SUBJECT: Requests relief from provisions of ASME Section XI - 1974,
 Table IWB-2500 exam Categories B-L-1 & B-L-2 for reactor
 coolant pump.

March 8, 1984
AKP:NRC:0070M

Donald C. Cook Nuclear Plant Unit Nos. 1 and 2
Docket Nos. 50-315 and 50-316
License Nos. DPR-58 and DPR-74
Inservice Inspection Program - Code Relief

Figure 1

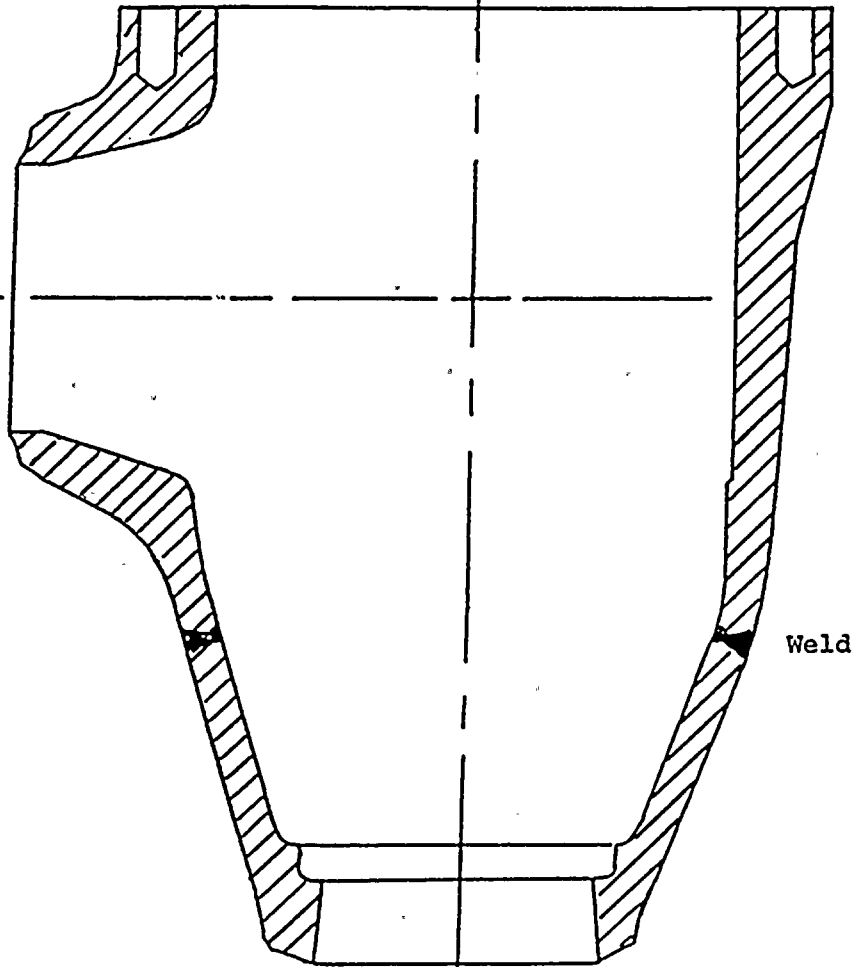
This submittal is made pursuant to Title 10 of the code of Federal Regulations, Part 50.55a (g) (6) (i), and requests code relief from the provisions of ASME Section XI - 1974, Table IWB-2500 examination categories B-L-1 and B-L-2 for the reactor coolant pump. Section XI, category B-L-1, covers volumetric examination of 100% of the pressure-retaining welds and category B-L-2 covers visual examination of the internal pressure boundary surfaces. These examinations are required for at least one of a group of pumps performing similar functions in the system. Section XI indicates that these examinations may be performed at or near the end of the inspection interval. Indiana & Michigan Electric Company requests relief from the above categories of examinations for the Donald C. Cook Nuclear Plant. The basis for requesting code relief is that the substantial radiation exposure that the inspection personnel will incur and the substantial costs involved do not justify the possible information that might be gained about the weld and adjacent base metal.

The pump casing is made from ASME SA-351, Grade CF-8M, a cast austenitic stainless steel that has a long history of satisfactory service in handling fluids. The casing was made in two sections to facilitate the casting process and the two sections are welded together with a matching filler material. Welding case CF-8M material to repair imperfections is a routine practice for almost all CF-8M castings, except those of simple configuration and small size. The material has good fracture toughness, and unlike ferritic steels, is not subject to fracture prevention criteria.

Volumetric examination will require a substantial number of radiographic exposures that will require complete disassembly of the pump (Figure 1). Disassembly of the pump, storage of the internals, and placement of film will expose personnel to substantial radiation. From experience at other nuclear plants examining reactor coolant pumps, personnel exposure could be in the range of between 35 to 100 man-rem.

As an alternate to the B-L-1 and B-L-2 examination, a visual examination will be performed on the external surfaces of one pump during the hydrostatic pressure tests. In addition, a surface examination will be performed on this pump on the accessible external surface of the weld.

If a pump has to be disassembled for maintenance, a visual examination will be made of the internal surfaces to satisfy the B-L-2 code requirement and the volumetric examination to the B-L-1 requirement reevaluated at that time.
